SAN LUIS OBISPO COUNTY
DEPARTMENT OF PUBLIC WORKS

May 27, 2015

**ADDENDUM NO. 1 TO
CSA 23 / AMWC / GARDEN FARMS CWD
EMERGENCY INTERTIE PROJECT
SANTA MARGARITA, CA
CONTRACT NO. 300536**

ALLEN BLOCK WALL – ELEVATION VIEW

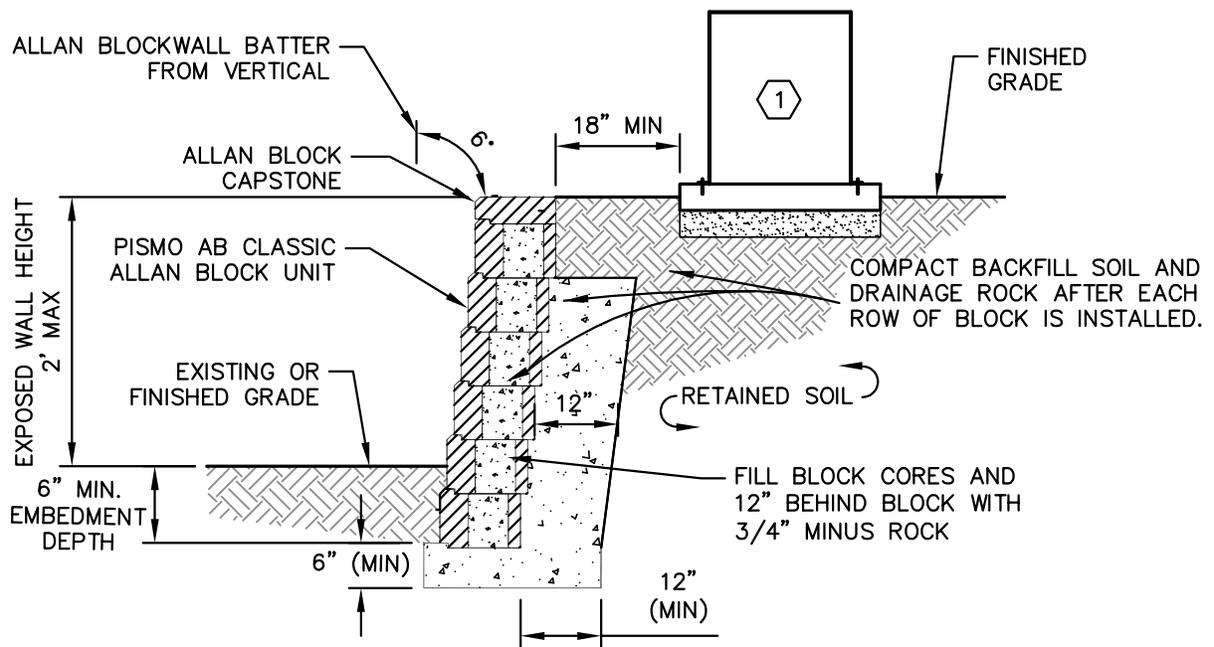
“Where required and/or as directed by the Engineer, Allan Block (or equivalent) retaining wall shall be constructed to adjust grades on fill slopes for ARV assemblies. Construction of retaining walls shall be in accordance with Detail 8, “Allen Block Wall – Side View,” shown on Sheet 19 of the Project Plans. For the purposes of bidding, the Contractor shall assume that three of the ARV assemblies will require such retaining wall construction.”

22) Add the attached "Allen Block Wall – Elevation View" detail to Sheet 19, as Detail 8.
